**COMMITTEE OF ADJUSTMENT
REPORT SUMMARY
MINOR VARIANCE APPLICATION
FILE NUMBER A037/22**

AGENDA ITEM NUMBER: 6.1	CITY WARD #: 1
APPLICANT:	Luigi & Loredana Guarascio
AGENT:	Andre Grisolia
PROPERTY:	17 Winterlude Ct Kleinburg
ZONING DESIGNATION:	See below.
VAUGHAN OFFICIAL PLAN (2010) DESIGNATION:	Vaughan Official Plan 2010 ('VOP 2010'): "Low-Rise Residential"
RELATED DEVELOPMENT APPLICATIONS:	None
PURPOSE OF APPLICATION:	Relief from the Zoning By-law is being requested to permit the construction of a proposed loggia, cabana and retaining wall located in the rear yard.

AGENDA ITEM NUMBER: 6.1	CITY WARD #: 1
APPLICANT:	Luigi & Loredana Guarascio
AGENT:	Andre Grisolia
PROPERTY:	17 Winterlude Ct Kleinburg
ZONING DESIGNATION:	See below.
VAUGHAN OFFICIAL PLAN (2010) DESIGNATION:	Vaughan Official Plan 2010 ('VOP 2010'): "Low-Rise Residential"
RELATED DEVELOPMENT APPLICATIONS:	None
PURPOSE OF APPLICATION:	Relief from the Zoning By-law is being requested to permit the construction of a proposed loggia, cabana and retaining wall to be located in the rear yard.

PROPOSED ELEVATION AT REAR OF PROPERTY TO DEMONSTRATE RATIONAL OF RETAINING WALL AND CABANA HEIGHT IN RELATION TO GRADES FROM PROPERTY LINE TO PROPERTY LINE

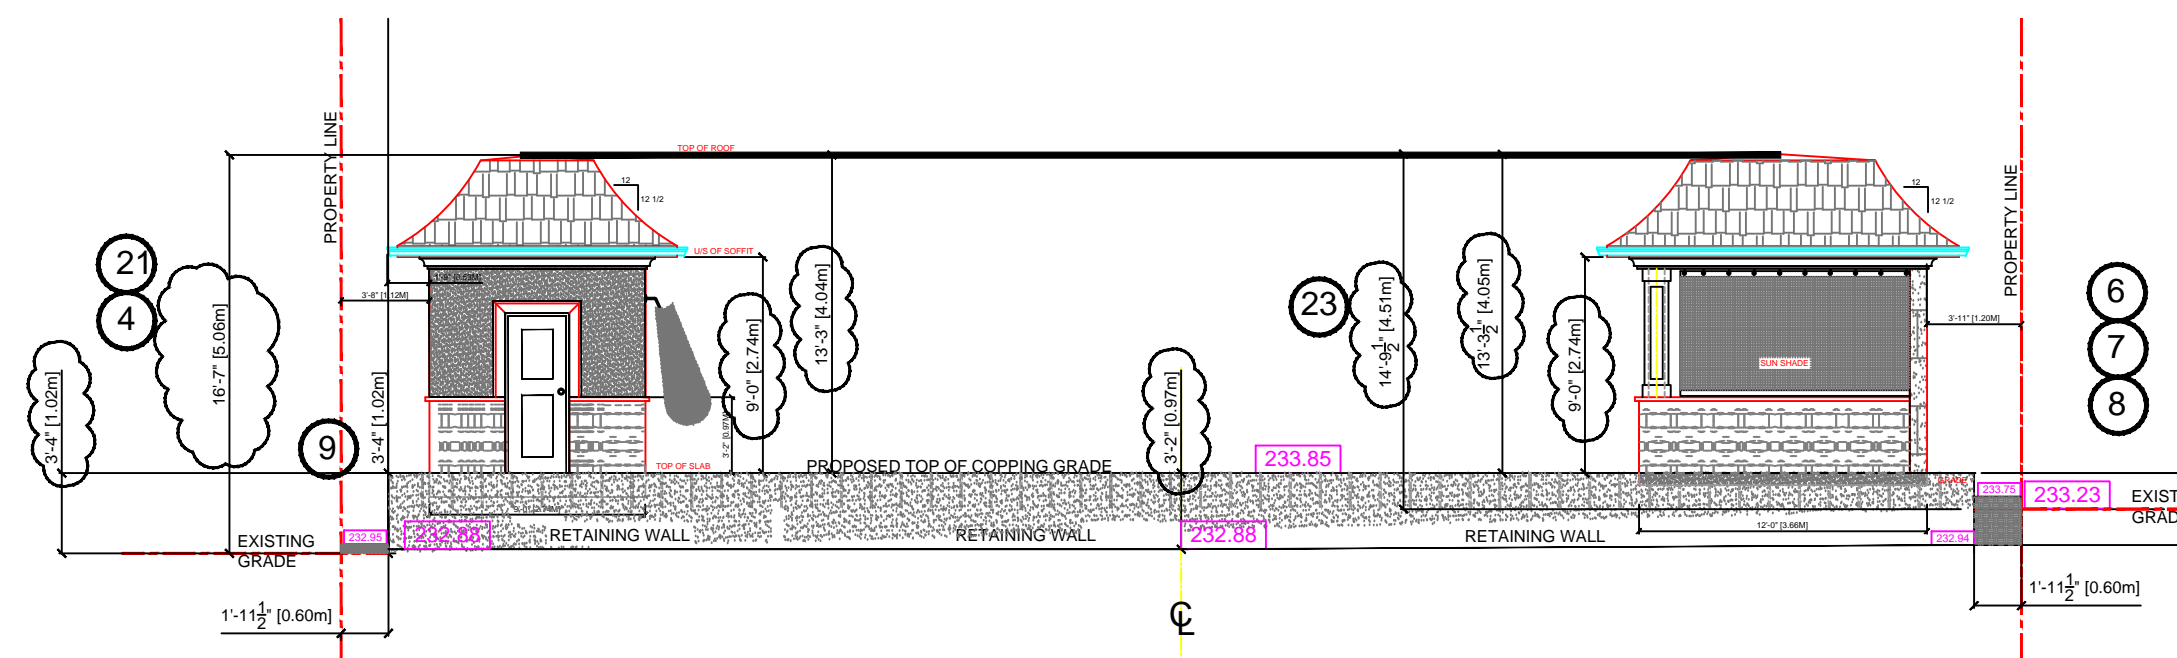
Development Engineering Department does not support the variances 9 and 19 of the variance application A037/22. Retaining walls are to be constructed in accordance with the City of Vaughan Lot Grading Criteria. Retaining walls exceeding 1.0 meter in height shall be designed, inspected and certified by a Professional Engineer and shall be served by guards or otherwise treated to reduce any public hazard. A retaining wall which exceeds 1.0 meter in height must be set back from the nearest property line or distance equal to its height.

DRAWING NUMBER: A-2

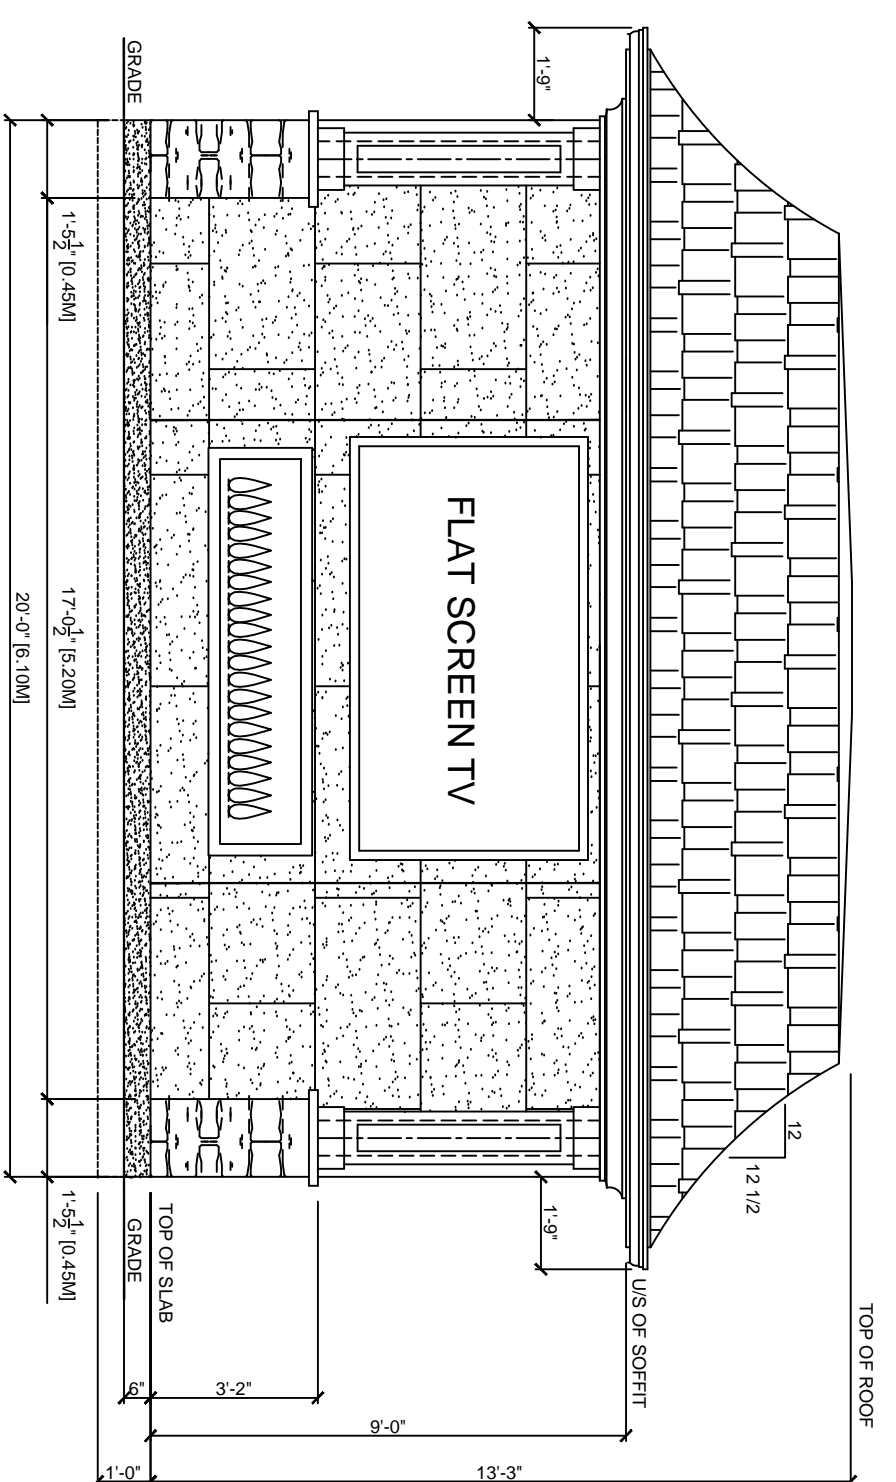
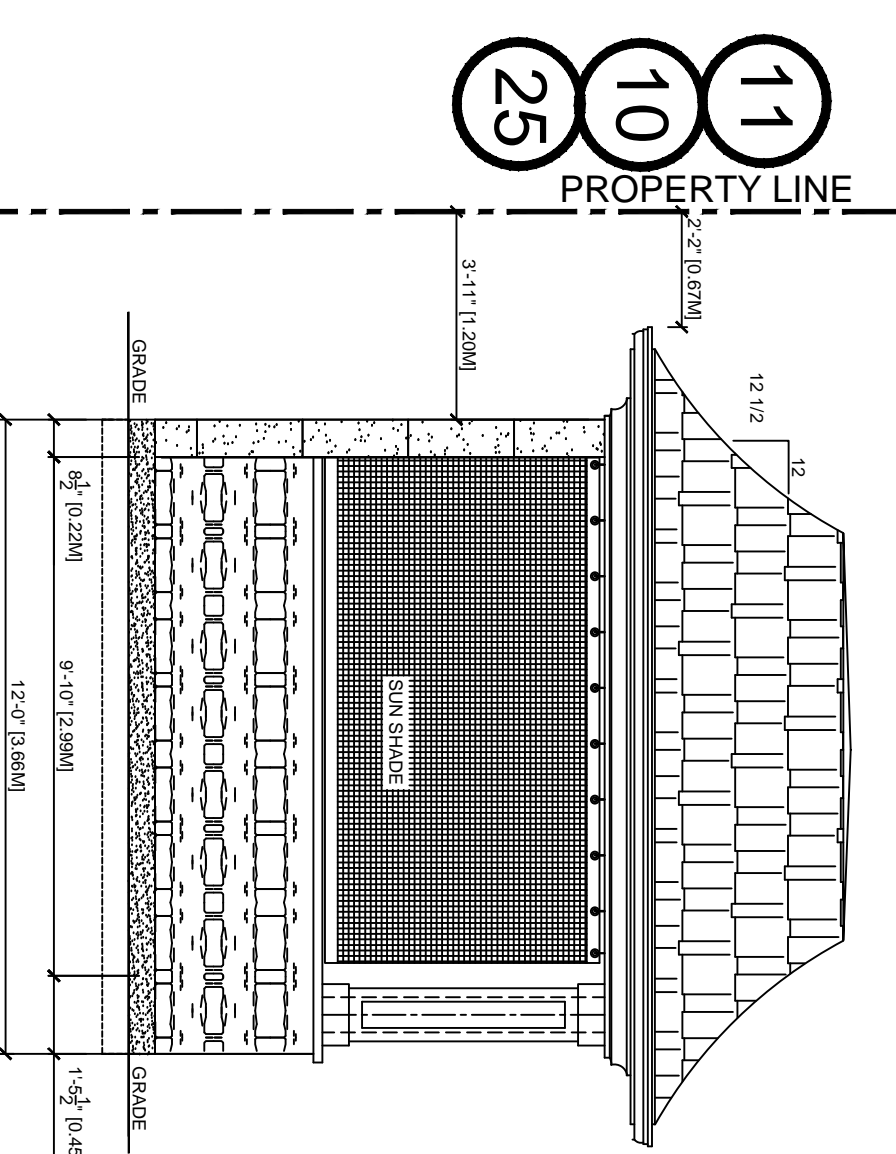
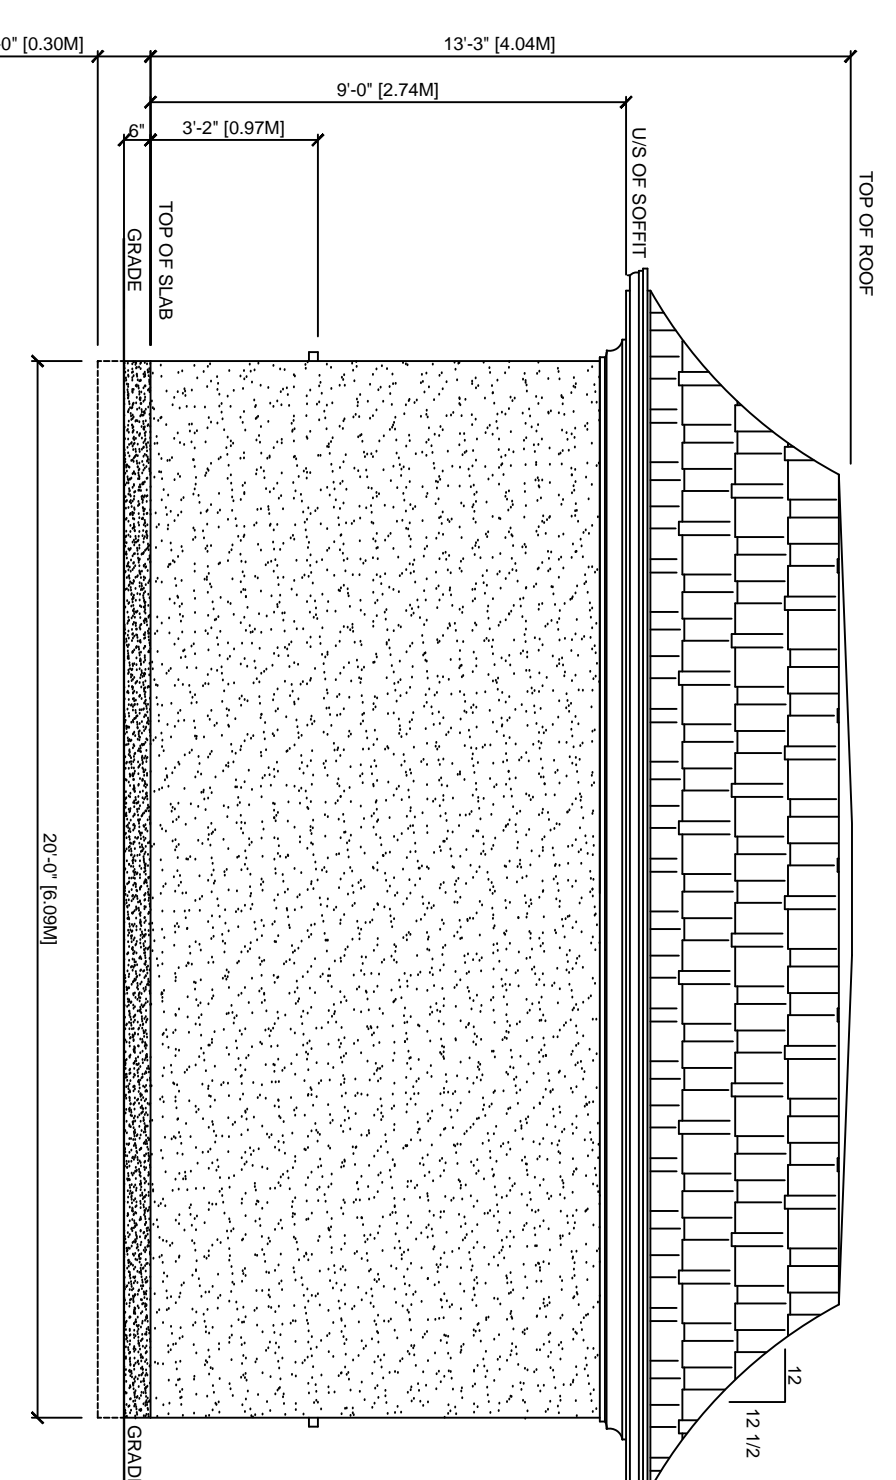
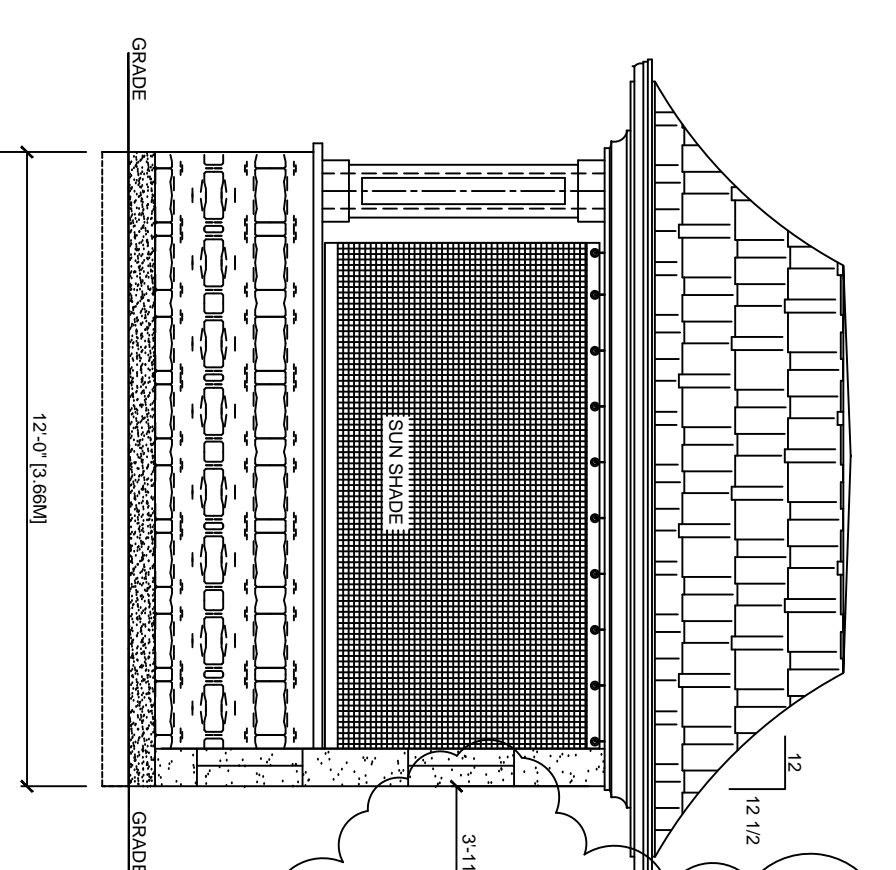
Proposed Loggia shows some type of fireplace under the Flat Screen TV.	
There is no note to the type of fuel. Electric, natural Gas, or propane. No solid fuel burning unit and chimney to be permitted.	
Fire Department Recommended Conditions of Approval:	None
